Re: Dr. Adkins Dental Office Renovation
10429 Montgomery Parkway Loop NE
Albuquerque, NM 87111
Traffic Circulation Layout
Engineer's Stamp XX-XX-XX (F21-D037Q)

Based upon the information provided in your submittal received 10-09-25, the above referenced plan cannot be approved for Building Permit until the following comments are addressed:

Sheet TCL-001

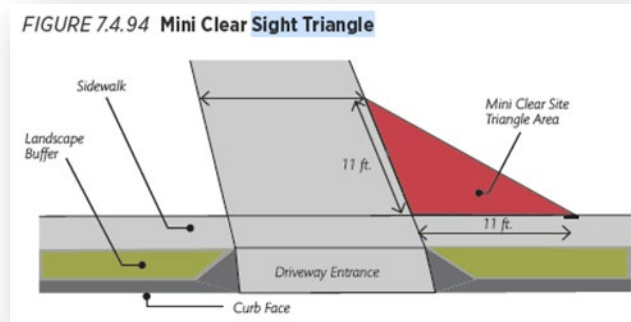
2. Show north arrow on plan sheet.
3. Identify the right of way width, medians, curb cuts, and street widths on Lagrima De Oro Rd. and Montgomery Parkway Loop NE.

4. Show existing driveways on the adjacent properties and properties across the street from the site. Indicate distancing from these existing driveways to nearby proposed site accessways.

5. Proposed accessways must be set back from the property line such that the top landing for the ramp built as part of these accessway does not encroach in the area immediately in front of the adjacent property. Also, the end of the curb radius for these accessways shall not extend to this area.

6. All accessways to the site from the adjacent roadway shall be ADA-compliant.
7. Provide additional driveway access details for existing access on Montgomery Parkway Loop NE.

8. We notice the site triangle detail drawing; however, site access drawing does not reflect detail drawing. Site triangle starts at and behind the sidewalk.

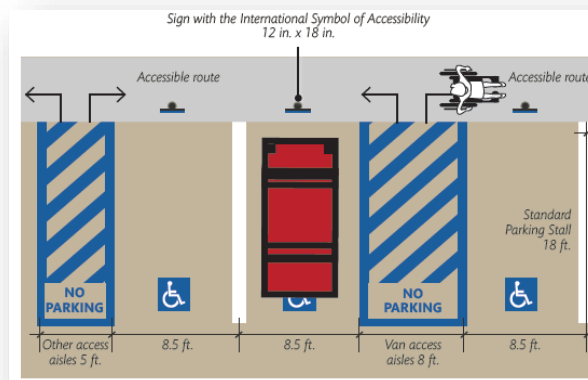
9. Provide design details and City standard drawings for all ADA ramps.
10. Call out ADA parking and access aisle widths on site plan.
11. Parking striping detail calls out white access aisle striping. ADA access aisles shall have blue diagonal striping and the words "NO PARKING" in capital letters, each of which shall be at least one foot high and at least two inches wide, placed at the rear of the parking space so as to be close to where an adjacent vehicle's rear tire would be placed (66-1-4.1.B NMSA 1978). Update detail drawing as well.

FIGURE 7.4.115 Bicycle Parking Stall Layout Options

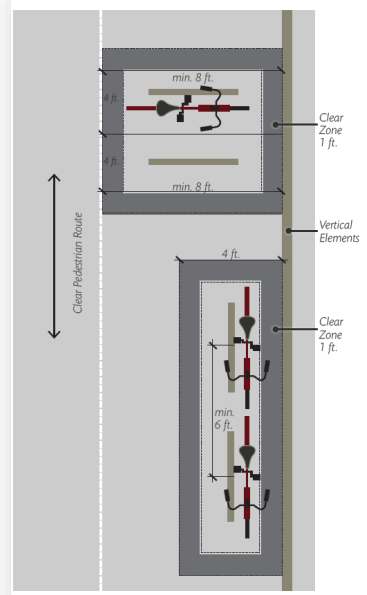
15. Provide Zoning approval for parking calculations.
16. Bicycle parking spaces shall be located, sized, and constructed as required by IDO.
17. Bicycle racks shall be sturdy and anchored to a concrete pad.
18. A 1-foot clear zone around the bicycle parking stall shall be provided.
19. Bicycle parking spaces shall be at least 6 feet long and 2 feet wide.
20. Bicycle rack detail drawing shows a 3 foot bicycle parking stall and 1 foot clear zone. Bicycle parking spaces must be at least 2 feet wide, equaling a 4 foot bicycle parking stall and a 1 foot perimeter clear zone. Reevaluate and ensure perimeter is free of obstruction and protruding objects. Reflect on site plan.
